# Access Compliance Report

## Public Rights-of-Way

Intersection ID: 53894	Main Street: INVERNESS_BAY_RD	Cross Street: PERTH_MOOR_RD	Location: NW
ADA ID: 6AE4A2F413E7	Ramp Type: BlendTrans1	Initial Pass/Fail: Fail	Overall Compliance: No
		Severity Score: 8.75

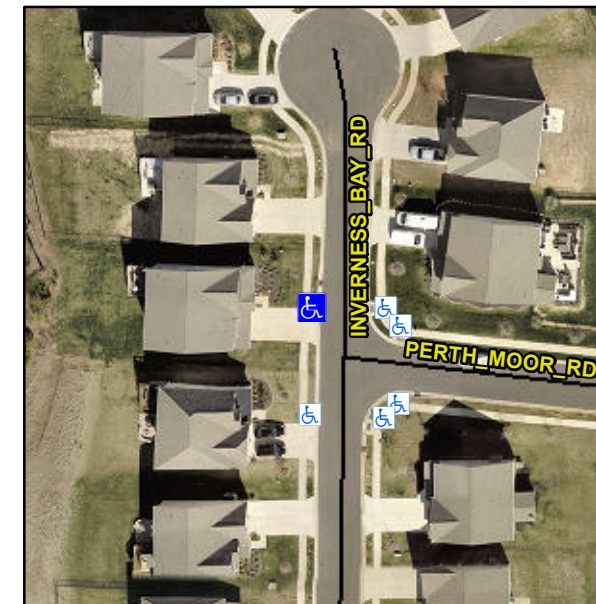
**Not Found, R304.5.1**

**Remove & Replace Curb Ramp With Two New Directional Ramps or Equivalent.**
